Bill Powers, PE  
Powers Engineering  
4452 Park Blvd  
San Diego, CA 92116

Public Hearing (9/16/09)  
Once Through Cooling  
Deadline: 9/30/09 by 12 noon

**Powers Engineering comments – Sept. 16, 2009 SWRCB Public Hearing** **E I V E**

# Diablo Canyon –location of cooling towers assumed by TetraTech

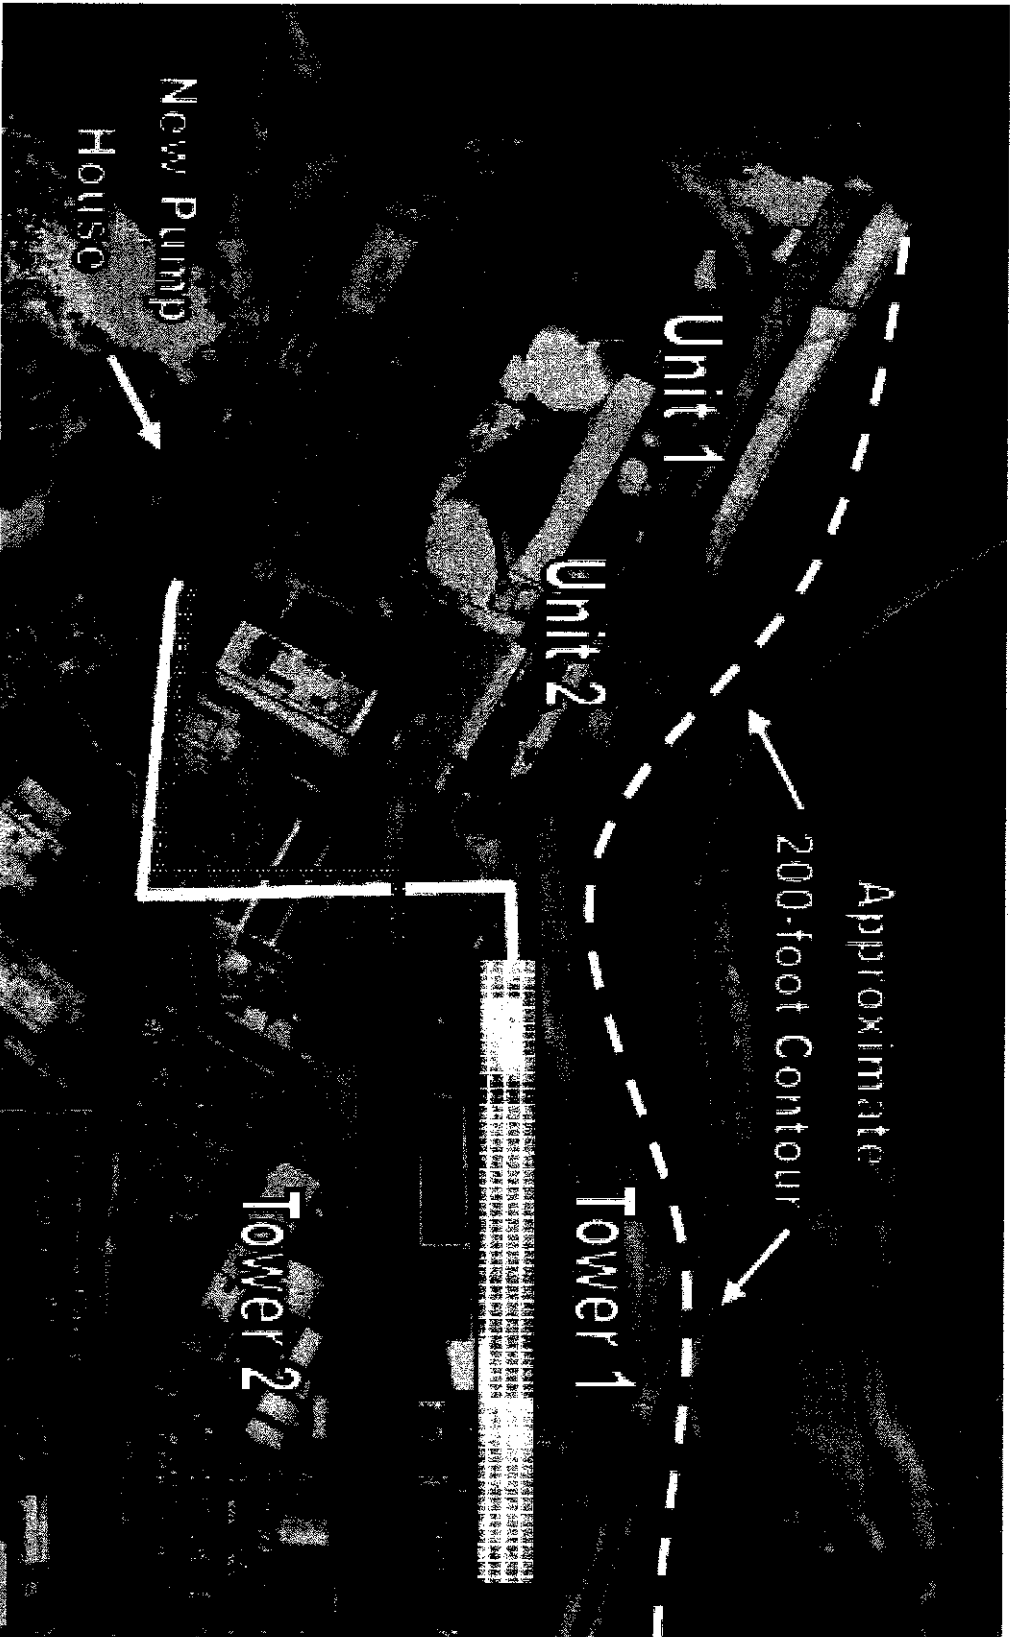
**The difference in cost estimates for cooling tower retrofits at Diablo Canyon and SONGS is driven by faulty assumptions on the need to demolish existing onsite structures, outage duration, and contingency costs.** The Ocean Protection Council's contractor, TetraTech, estimated approximately the same cost as SPX, \$150 million per reactor, for conventional cooling towers at Diablo Canyon in its February 2008 report on the cost and feasibility of cooling tower retrofits. However, in the case of Diablo Canyon, the TetraTech cost estimate also includes \$300 million per reactor for demolition of existing onsite structures, undefined indirect costs, and 30% contingency. In addition, TetraTech assumes an 8-month outage for the cooling tower tie-in, at an estimated lost revenue cost of over \$350 million per reactor.

All of these additional costs are avoidable if better locations are chosen for the cooling towers and a realistic tie-in outage time is assumed. For example, TetraTech assumes a 4-week tie-in outage for the 700 MW units at Moss Landing. This is a reasonable assumption. An 8-month outage at Diablo Canyon for the same type of tie-in is not reasonable.

# Diablo Canyon – cooling tower locations locations that avoid existing structures

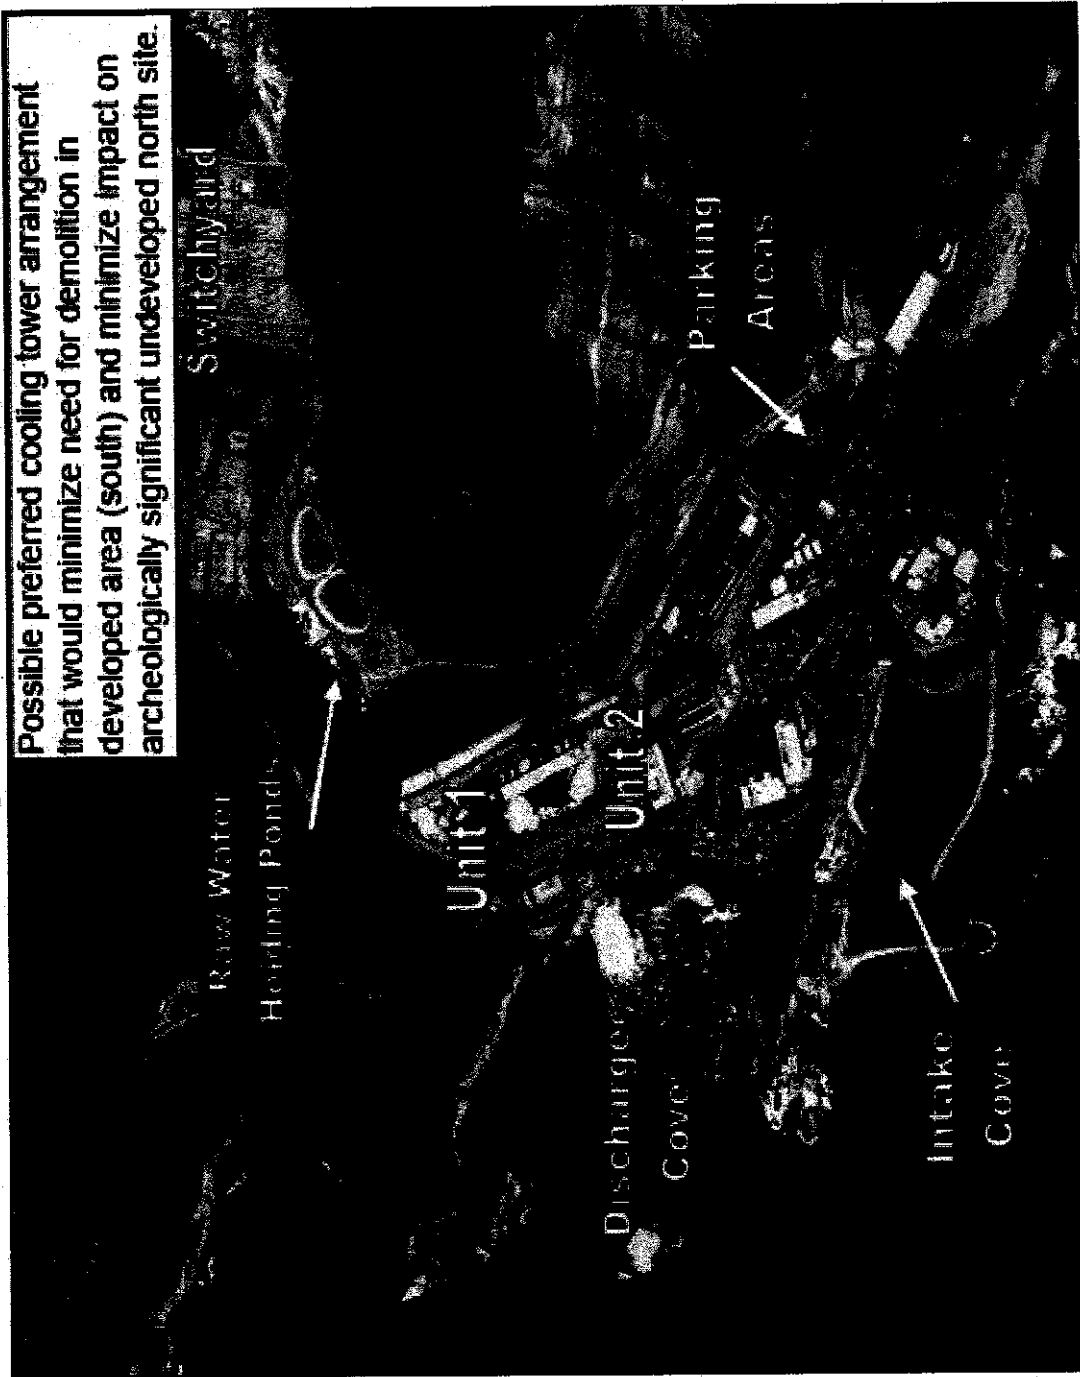
comment: red outlines of cooling tower locations and note added by B. Powers

Possible preferred cooling tower arrangement that would minimize need for demolition in developed area (south) and minimize impact on archeologically significant undeveloped north site.

# Tetrattech – assumed location of SONGS Unit 2 cooling tower

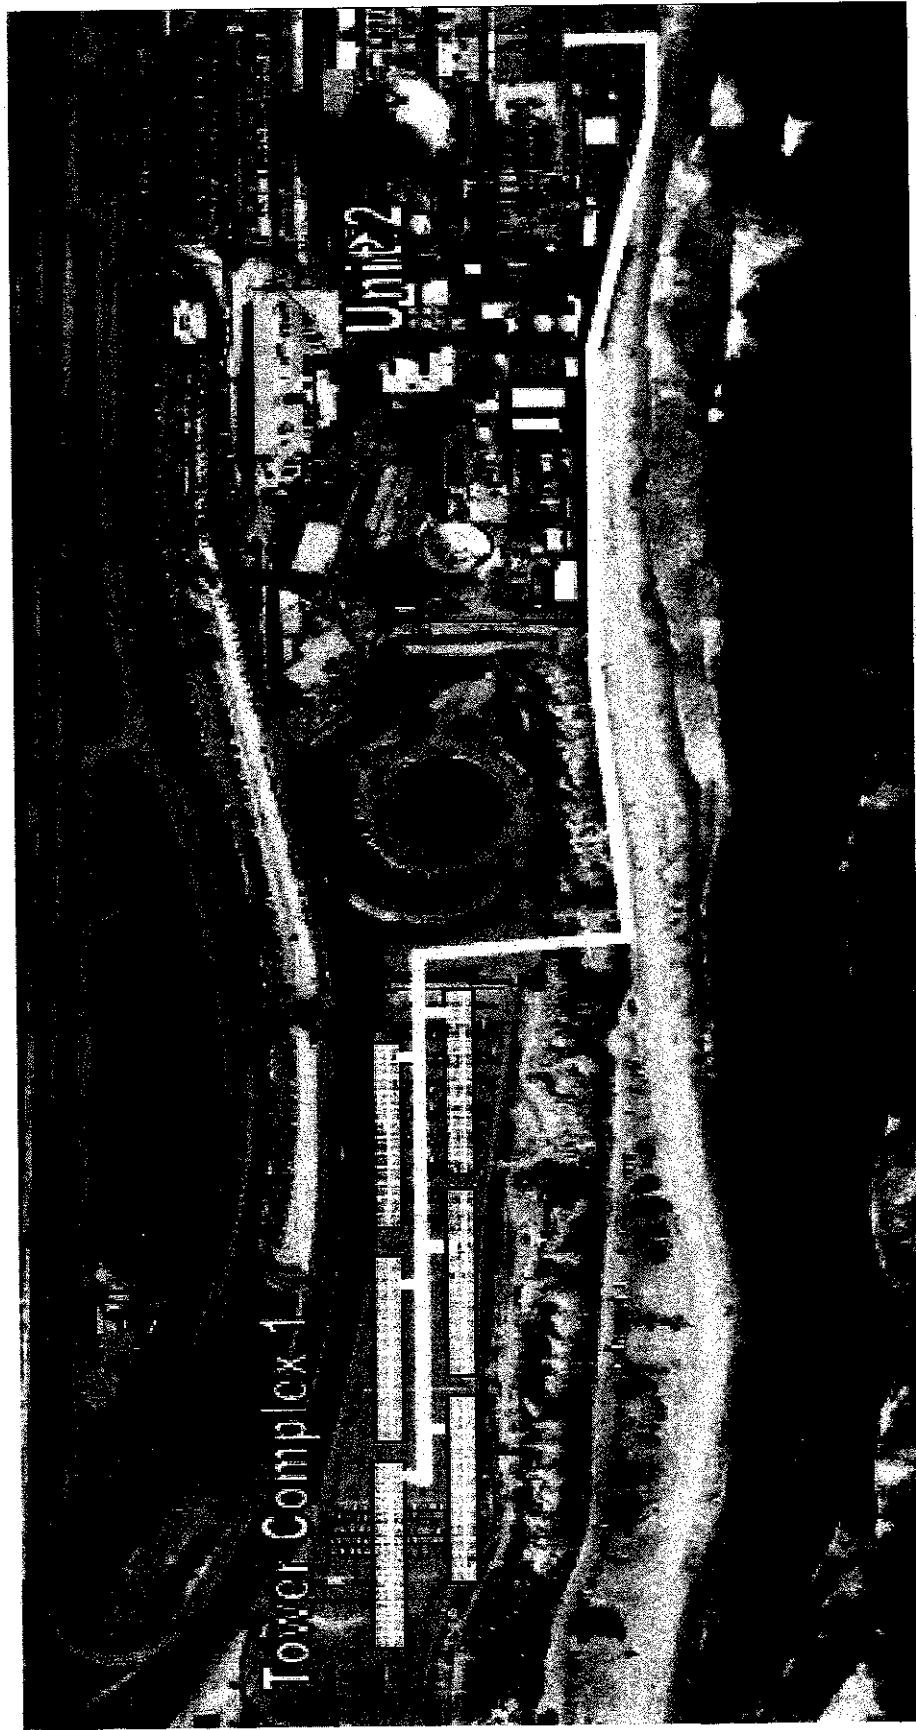
The TetraTech cost estimate for SONGS, at approximately \$230 million per reactor for a plume-abated cooling tower (without the 30% contingency), is the same as the SPX estimate. However, again without supporting justification, TetraTech assumes a 6-month outage to tie-in each cooling tower which results in \$300 million in lost power generation revenues per reactor.
